ET-NRC-92-3789
NSRA-APSL-92-0270
Docket No. STN-52-003
Proj 676
December 22, 1992

SUBJECT: WESTINGHOUSE RESPONSES TO NRC REQUESTS FOR ADDITIONAL
INFORMATION ON THE AP600

ET-NRC-92-3789
ATTACHMENT A
AP600 RAI RESPONSES
SUBMITTED DECEMBER 22, 1992

Figure 3.7.1-6 Acceleration Response Spectra of Design Horizontal Time History, "H1"

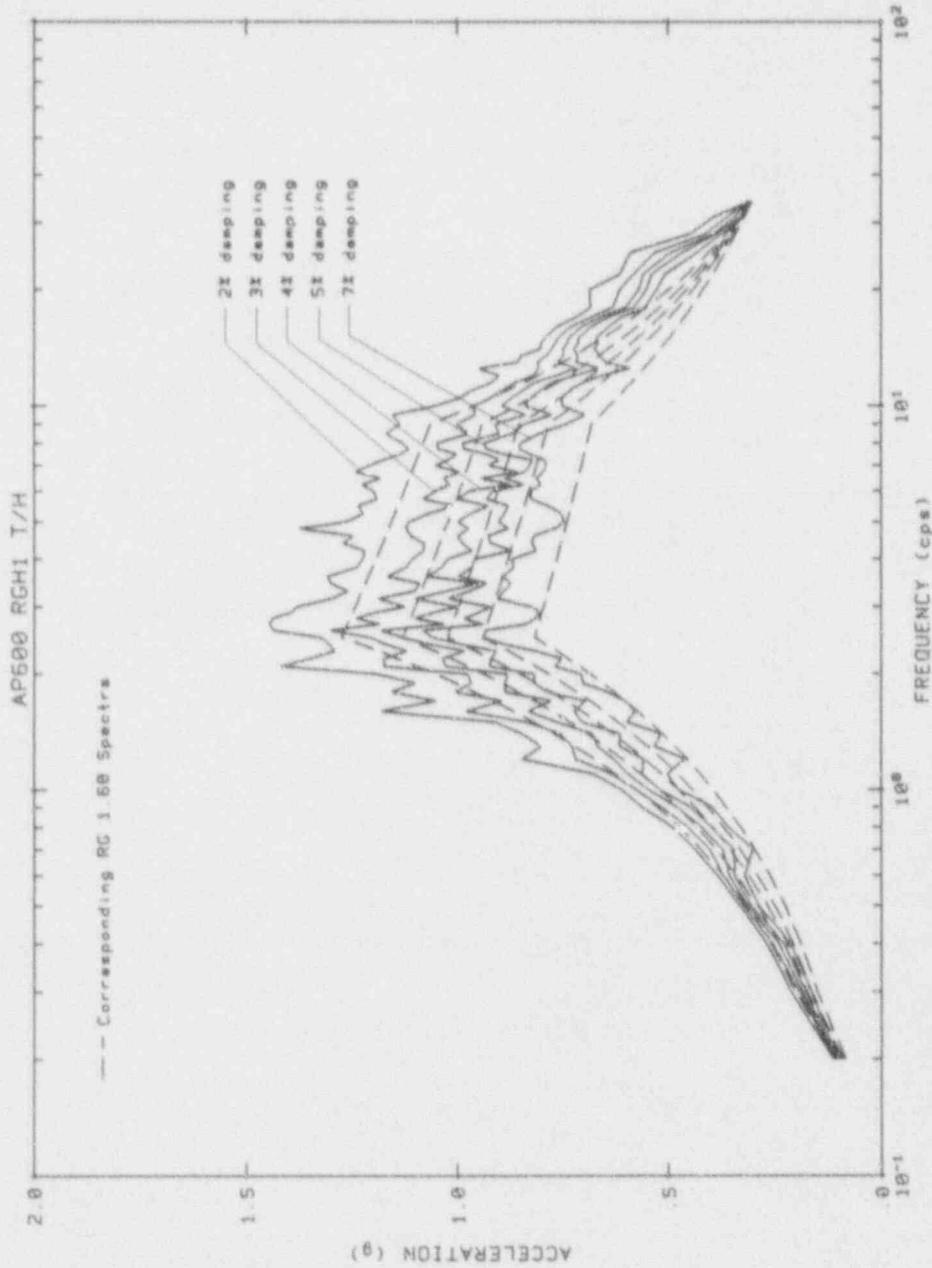
Section 3.7.1.2 of the SSAR states that the "TAFT" earthquake time history was used to generate synthetic time histories for AP600 seismic design. The SSAR presents spectrum comparison between the AP600 damped seismic design response spectra and the corresponding RG 1.60 response spectra anchored to 0.3 g for the damping ratios of 2, 3, 4, and 7% in Figures 3.7.1-6 through 3.7.1-8. However, the SSAR should also provide a spectrum comparison for the case with a damping ratio of 5%. Provide such a spectrum.

SSAR Figures 3.7.1-6 through 3.7.1-8 are revised to include the 5% damping response spectrum curves.

(SSAR Figures 3.7.1-6 through 3.7.1-8 will be revised as shown in attached sheets.)

Figure 5.4-2 Steam Generator

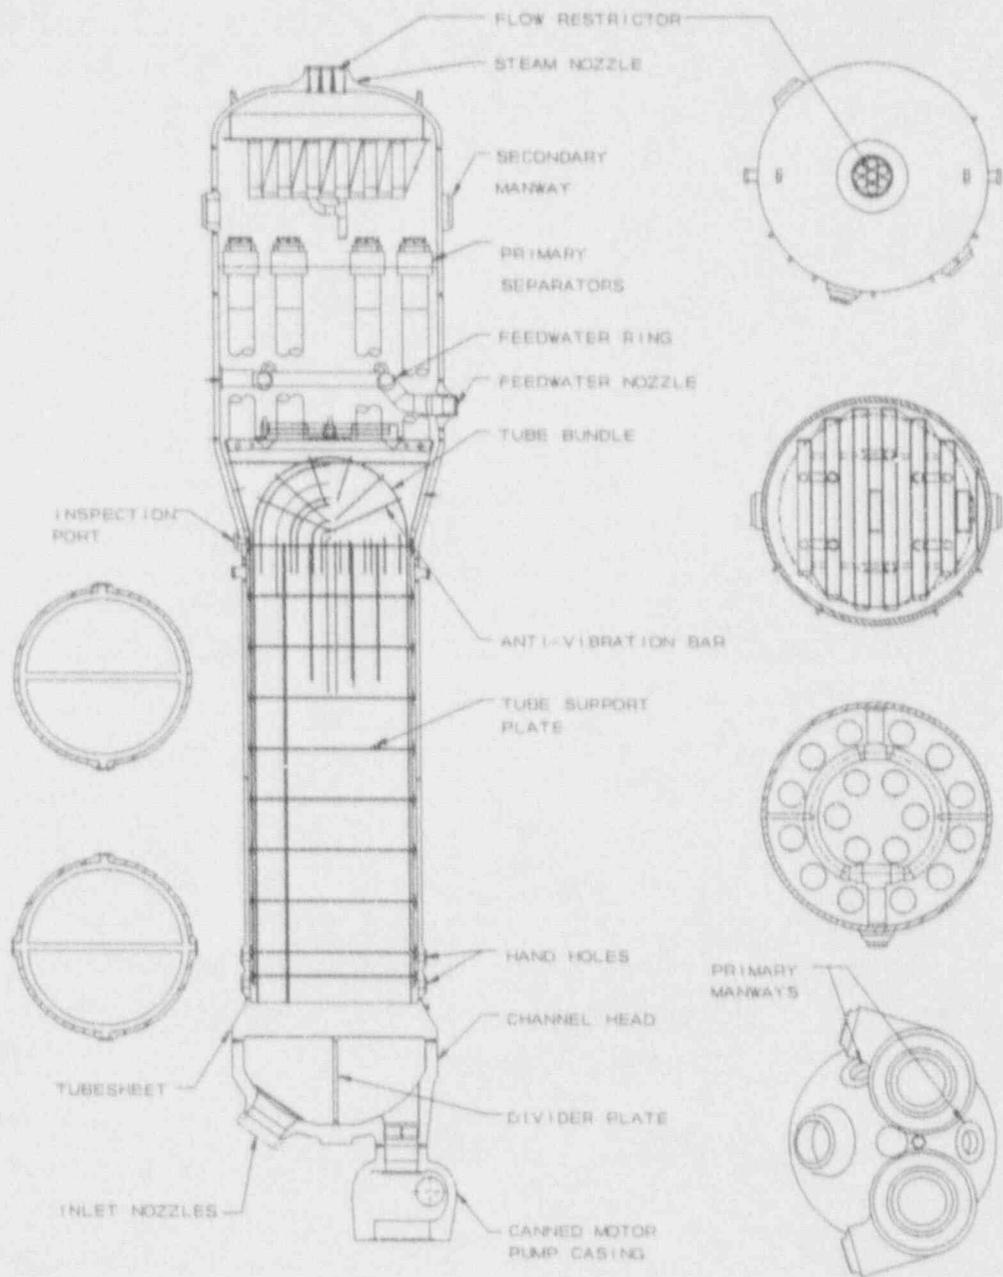
Figure 5.4-2 in the SSAR does not show the orientation and location of all of the access points in the steam generator. Provide drawings to show the secondary side access points in the steam generator.

There are six 6 inch handholes located in the lower part secondary shell. There are four 90° apart (two on the tubelane and two at 90° from the tube lane) that provide access to the secondary face of the tubesheet. The other two are 180° apart on the tubelane and provide access to the top of the flow distribution baffle. Two 4 inch ports located on the secondary shell in line with the tubelane and above the top tube support plate provide access to the U-Bend area. Please see the answer to RAI 250.12.

Figure 5.4-2 will be updated to show the location. The last paragraph of SSAR Subsection 5.4.2.4.2 will be revised to reflect this response as follows:
